Plan Commission

Agenda

Monday, February 25, 2019	7:00 PM	De Pere City Hall Council Chambers
---------------------------	---------	------------------------------------

6. Recommendation regarding a Site Plan for a building addition for Romo INC at 800 Heritage Road (Parcel ED-F0100-1). Submitted by Skyler Witalison, Mach IV Engineering, authorized representative for Darling Investments LLC, property owner.

C1.0

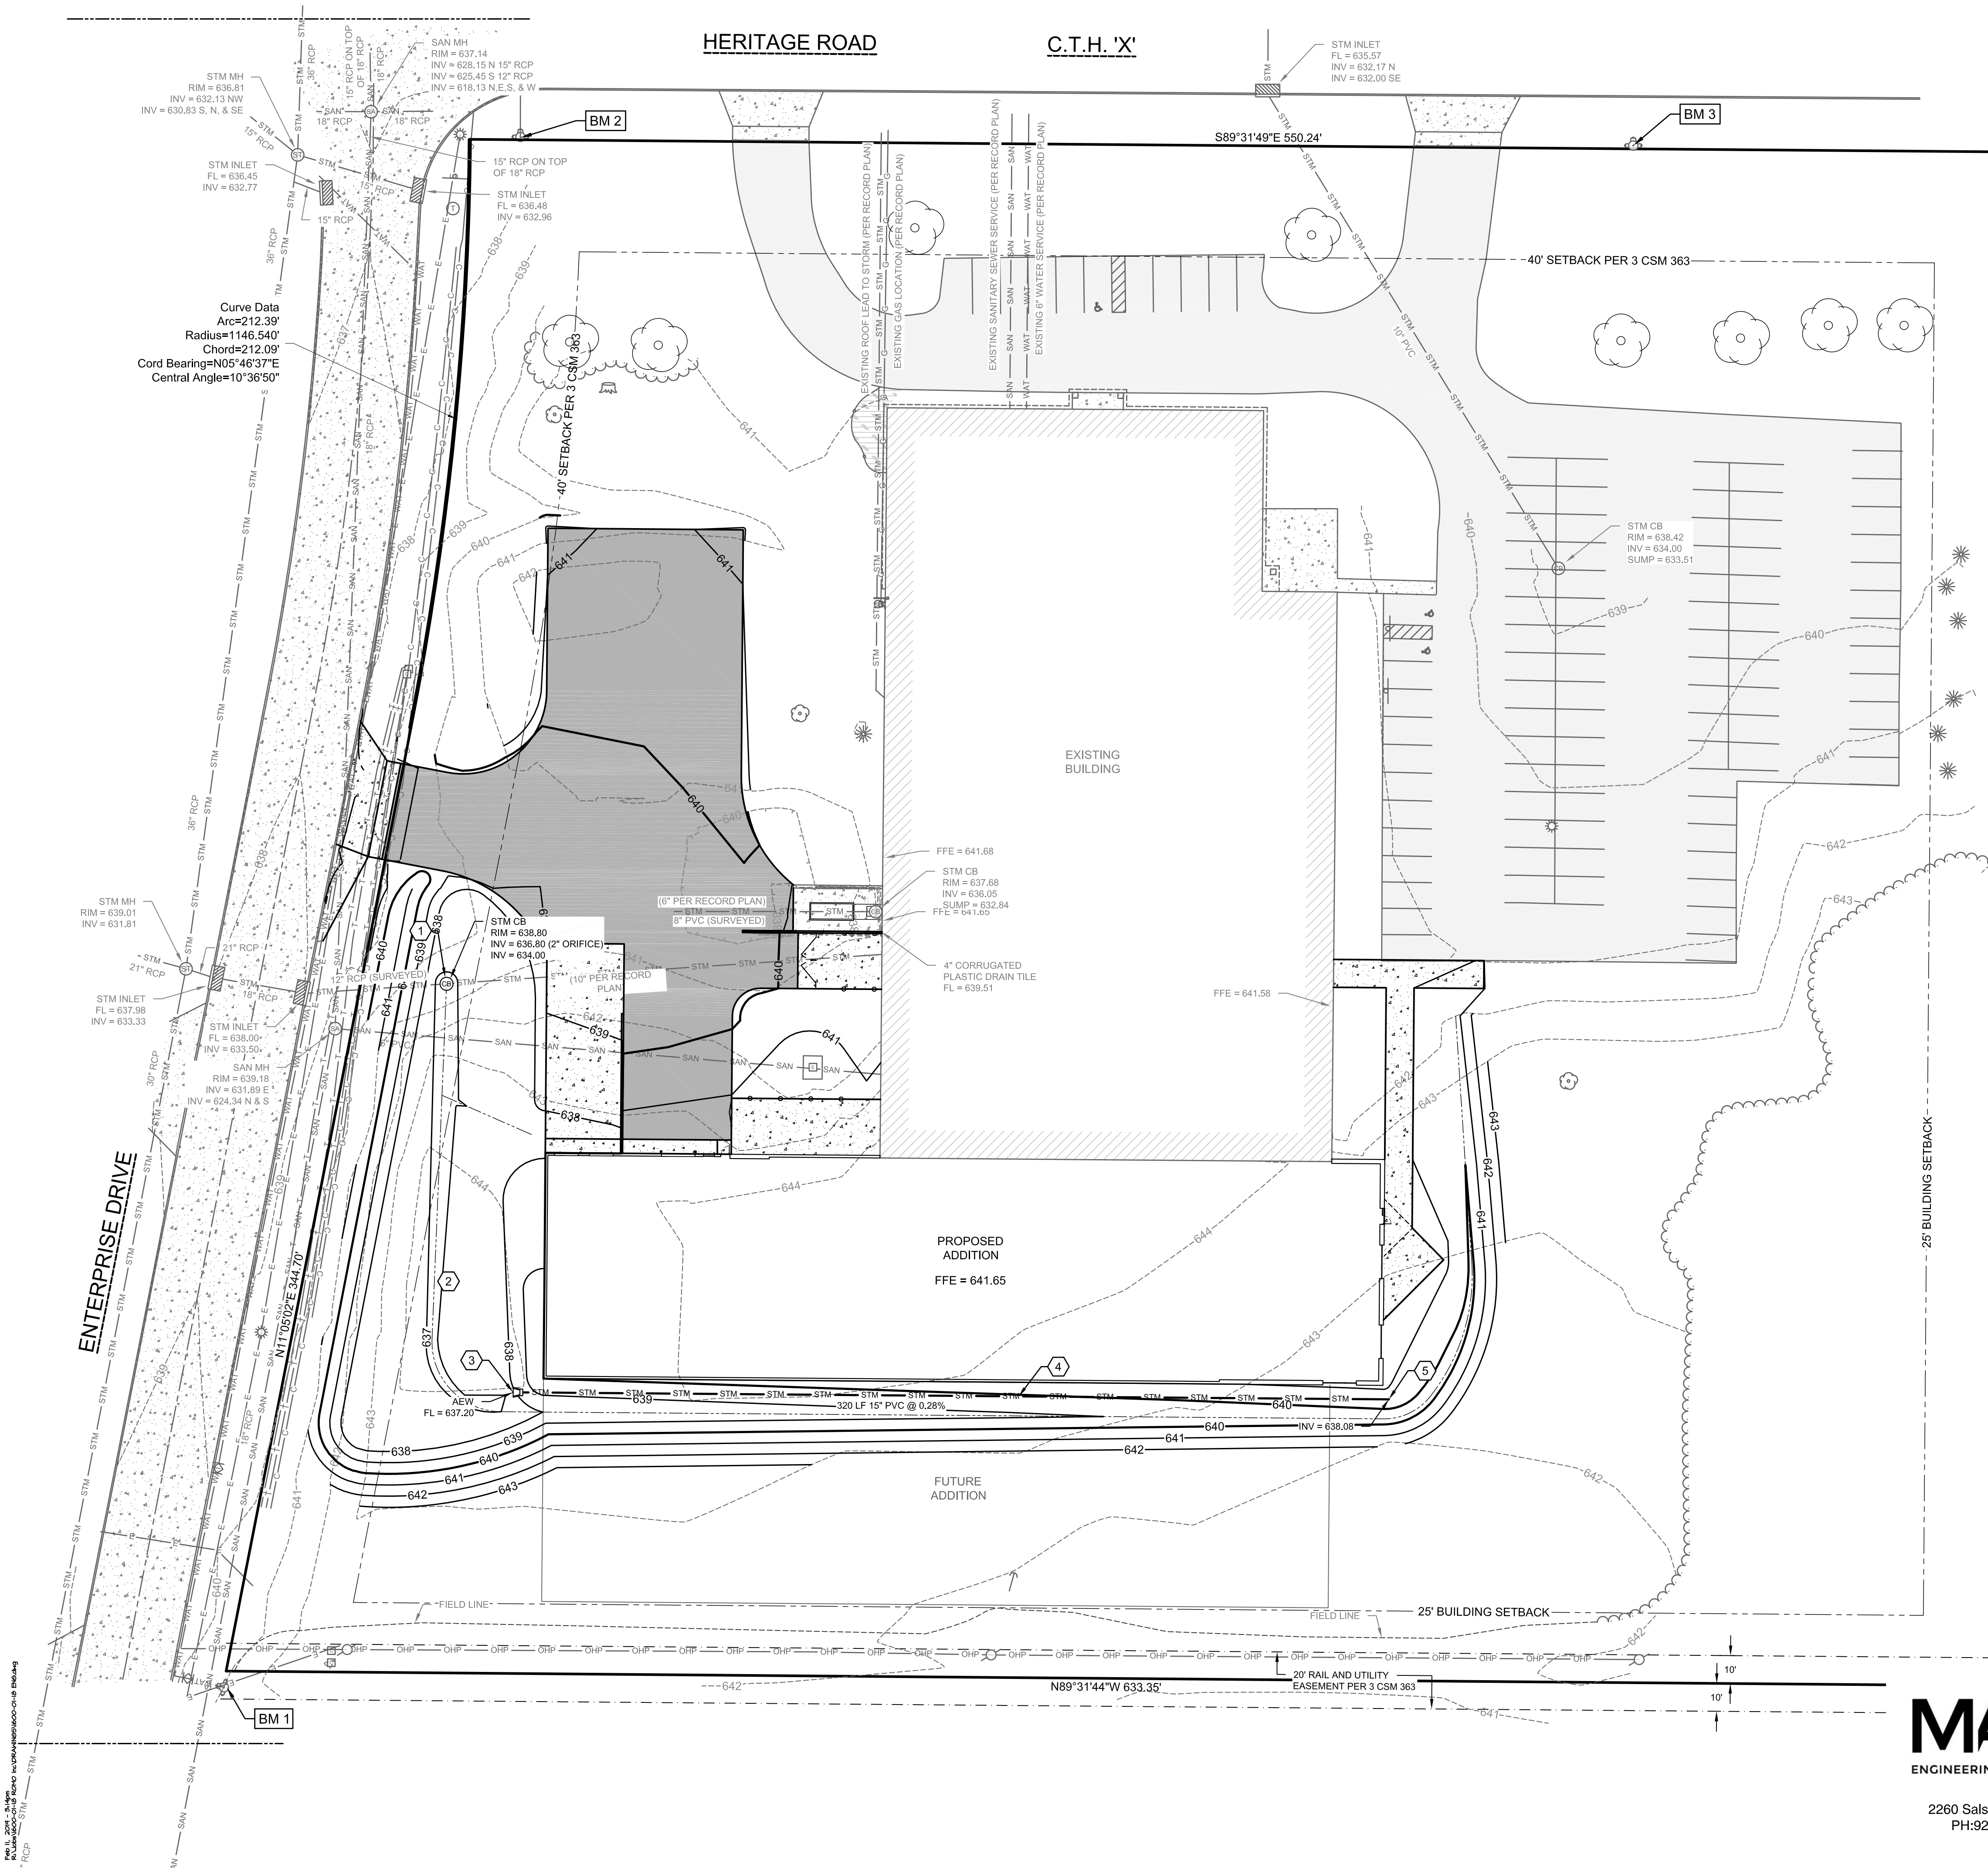
1st Sheet C1.0 (not civil plans) - Turning radius shown on the aerial drawing is no longer applicable. Enterprise Drive was reconstructed in 2018 and the road was narrowed by approximately 10 feet. Verify that trucks can access the site by pulling in, turning around, and backing into loading docks. Trucks currently back into driveway from Enterprise Drive.	KELLER C1.0 REMOVED FROM SET.
2nd Sheet C1.0 - I believe this sheet is incorrectly numbered and should be sheet C0.1.	RENUMBERED
2nd Sheet C1.0 - Need to provide property dimensions northing and easting for each property boundary.	ADDED, ALL SHEETS
2nd Sheet C1.0 - Why have comment 12?	ADDED "PRIVATE PROPERTY" TO NOTE
2nd Sheet C1.0 - (Typo) Comment 17 references sheet C0.1 when the legend and the abbreviations are on the same sheet (sheet C1.0). May be due to the sheet being misnumbered?	RENUMBERED
2nd Sheet C1.0 - Comment 18 references an erosion control plan on sheet C5.1. No such sheet exists.	C5.1 ADDED

3rd Sheet C1.0 - No Gas located. Where is gas service entering the building?	Locate gas service. FROM RECORD DRAWING
3rd Sheet C1.0 - Comment 9 - Curb and gutter is integral with concrete pavement. Entire panels will need to be replaced to accommodate work. Will need a excavation permit to complete work in the right-of-way. Per fee will be approximately \$1,000. CAN THIS WORK BE AVOIDED DUE TO ENTERPRISE DRIVE BEING BRAND NEW 2018 PAVEMENT?	MODIFIED ENTRANCE C1.0, C2.0, C3.0, C4.0

C3.0

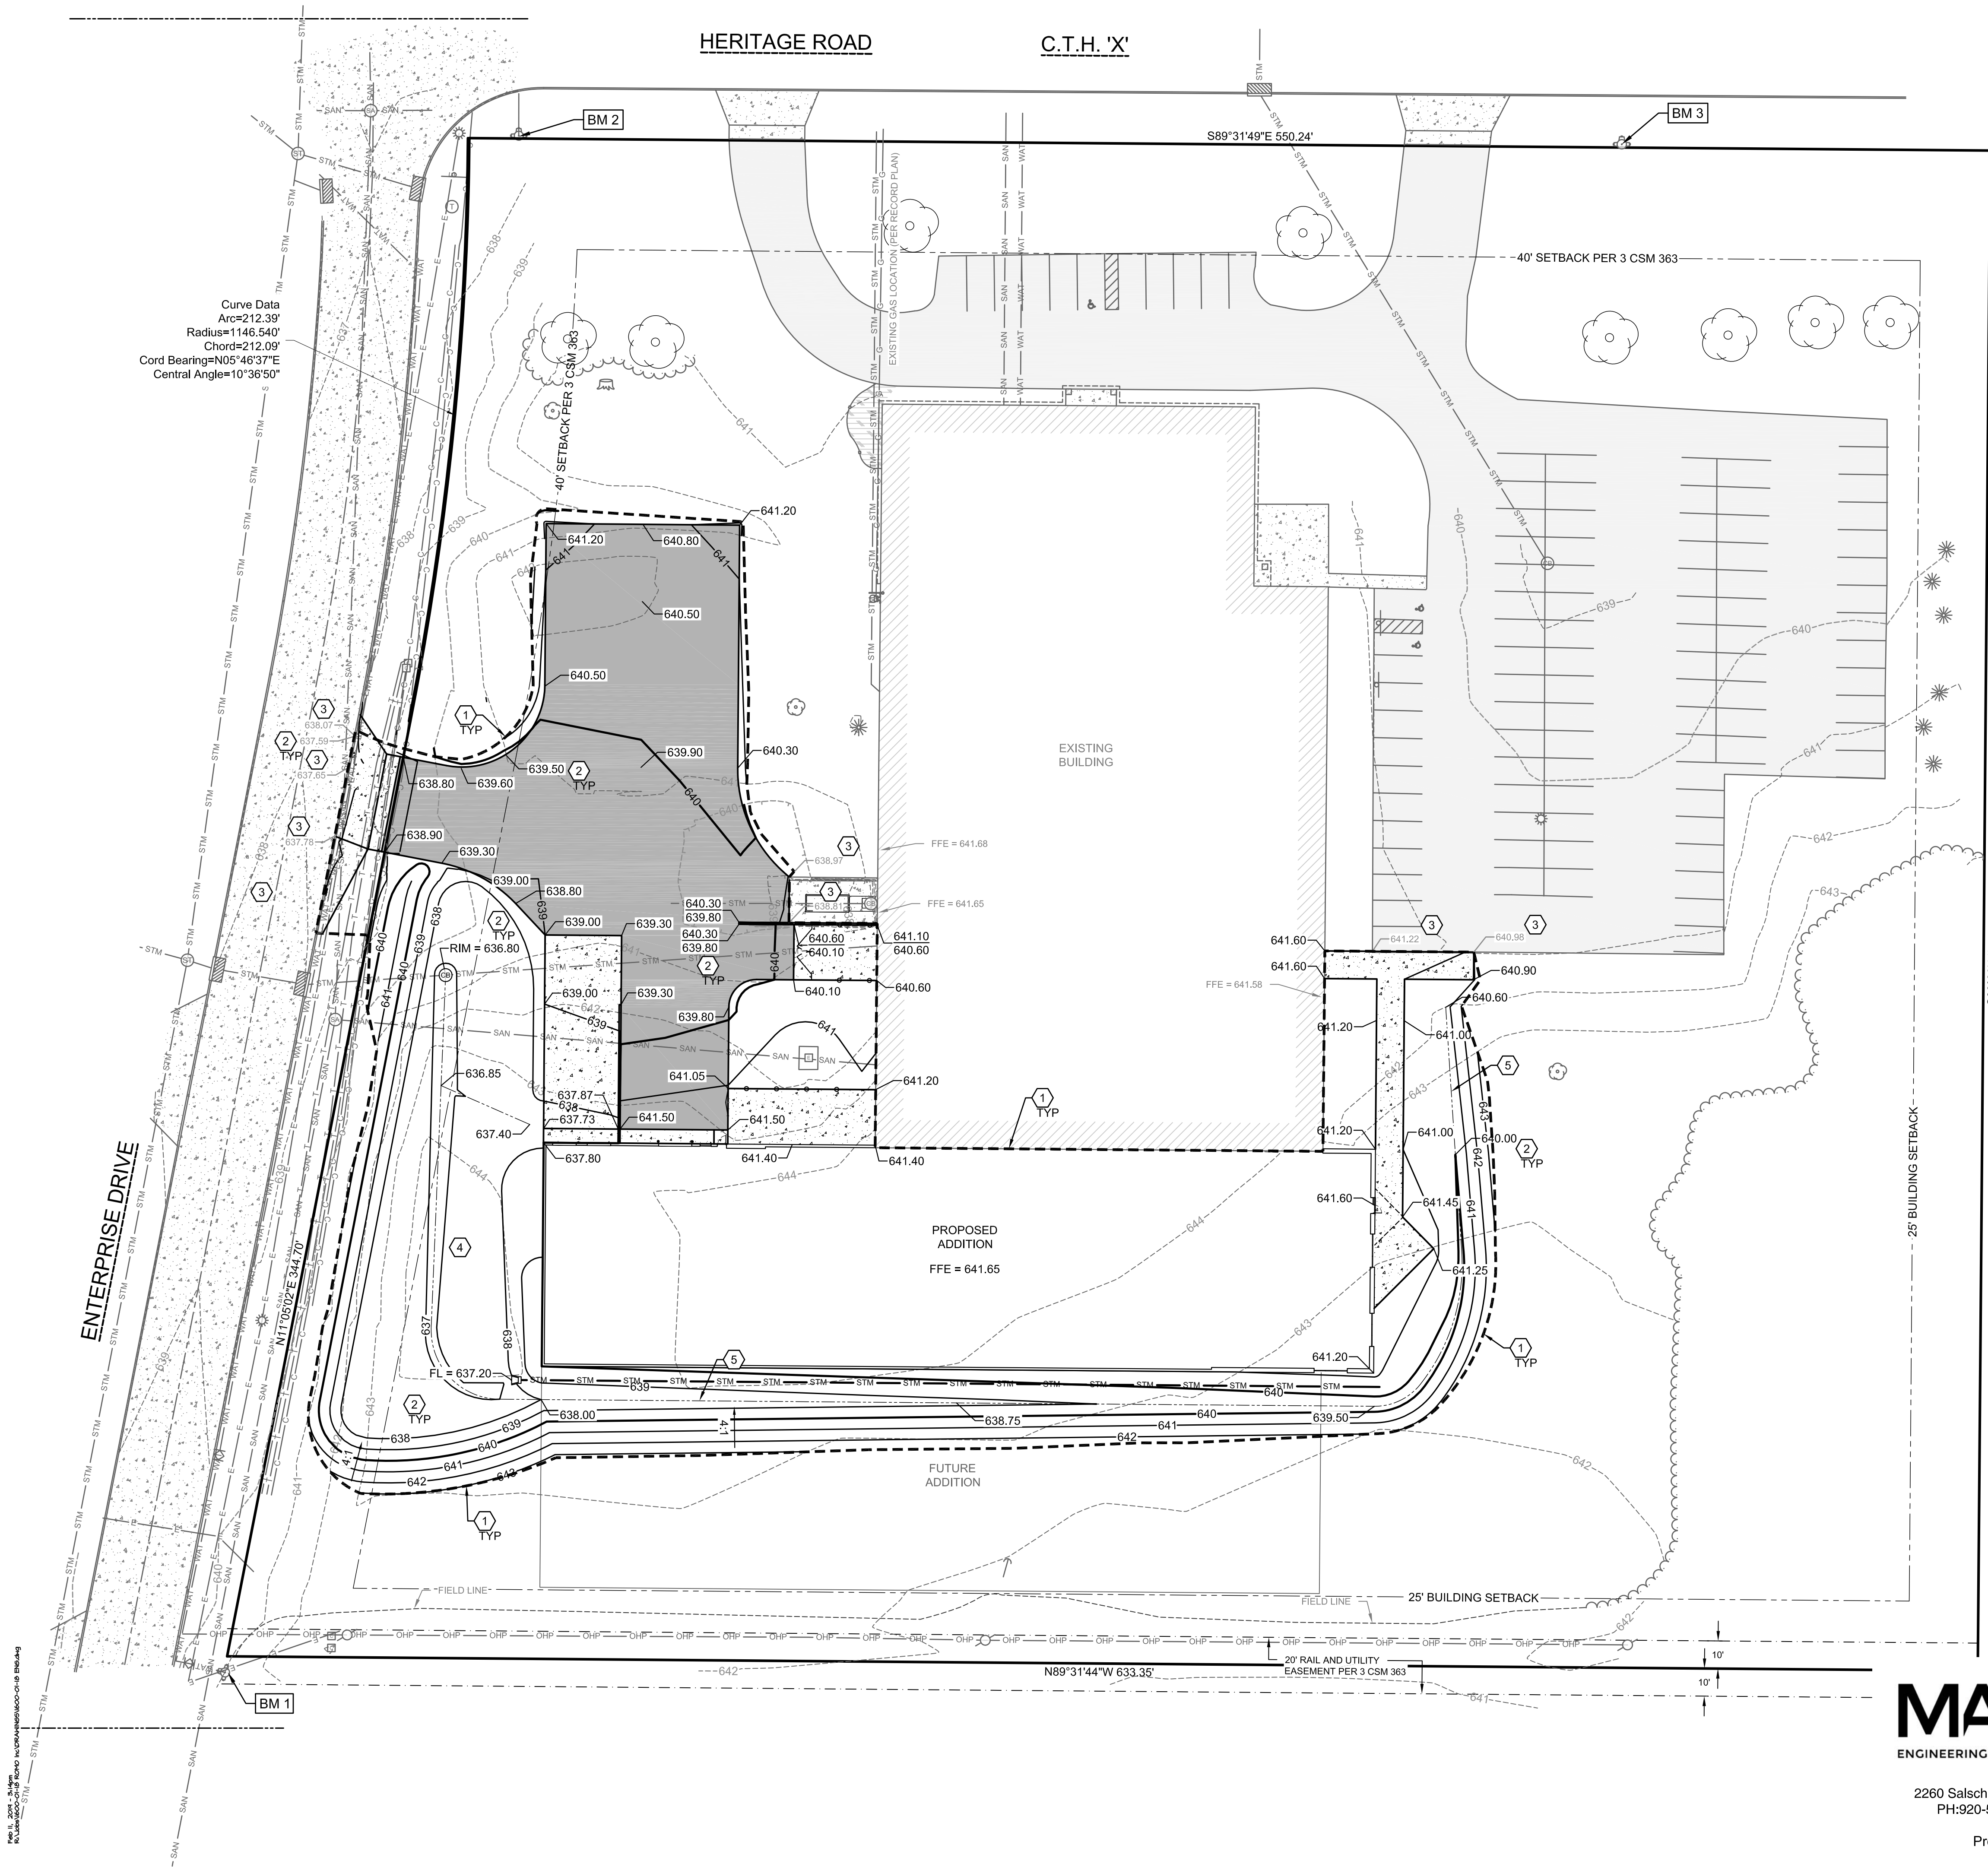
Sheet C2.0 - Driveway apron will need to be concrete and will need to have sidewalk section at the ROW line. All concrete in the street ROW shall be 8-inch thick. Due to concrete requirement, you may want to eliminate the radii.	C6.0

Sheet C2.0 - Not seeing a dumpster enclosure.	NOTE #10, C2.0
Sheet C2.0 - Parking lot does not meet ADA 2010 standard for accessible parking stalls. I count 110 parking stalls in total, which would require a minimum of five accessible stalls. One of the accessible stalls would need to be van accessible.	PARKING REMOVED N/A

Provide dimensions for driveways and parking areas. Include the size of parking stalls and painted stripes.	C2.0
Identify curbing around all parking areas and drive lanes. Use mountable curbing if water needs to flow over a curb as part of a SWMP.	O.K. PER CHASE
With the addition of the parking lot area, identify the total square footage of the parking lot. Also identify the amount of interior parking lot landscaping that is required (this is in addition to landscaping requirements) and identify where the landscaping is being placed to help minimize the mass of the paved parking area.	PARKING REMOVED C2.0
Provide an accurate count of the existing number of parking areas, proposed number with new addition, and the required number based on the facility use. The site plan has an area for stalls provided, but there is no area demonstrating the breakdown for number required (square footage, employees, work truck spaces, etc.).	SITE STATS C2.0
